U.S. Patent Application Serial No. 10/615,386 Amendment filed April 7, 2006 Reply to OA dated January 20, 2006

AMENDMENTS TO THE DRAWINGS:

4/6

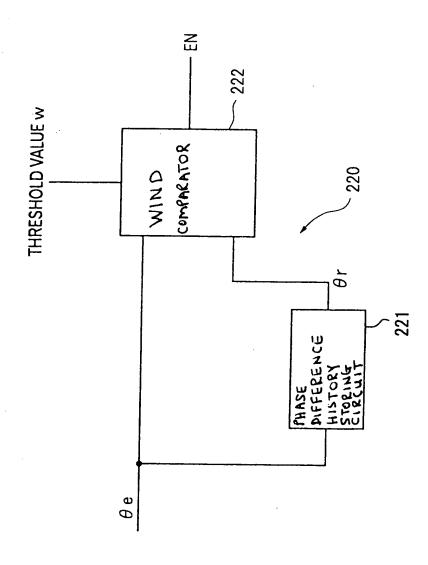
The drawings have been objected to for the reason set forth in item 3, page 2 of the

outstanding Action. In amended Figures 3 and 4, submitted herewith, the block boxes have been

labeled, as requested by the Examiner.

The attached sheet of drawings includes changes to Figures 3 and 4. This sheet, which includes Figures 3 and 4, replaces the original sheet including Figures 3 and 4.

In Figures 3 and 4, the block boxes have been labeled, as requested by the Examiner.
